Saiham Knit Composite Ltd (9520)

Saiham Nagar, Noyapara, Madhabpur, Hobigonj

28.May.2014

1st Priority 3 Concern

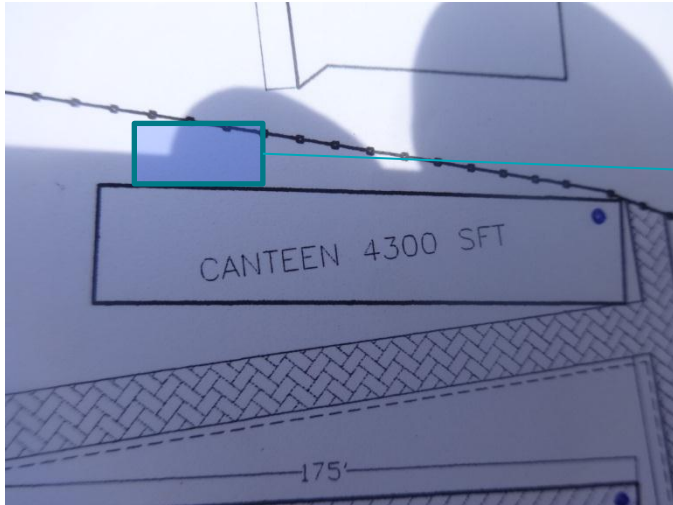
Both of these images show locations where a structural member has been cut to allow for the passage of a duct. Left, a purlin has been dismantled; while right, one angle from a section of cross bracing has been cut, rendering it useless.
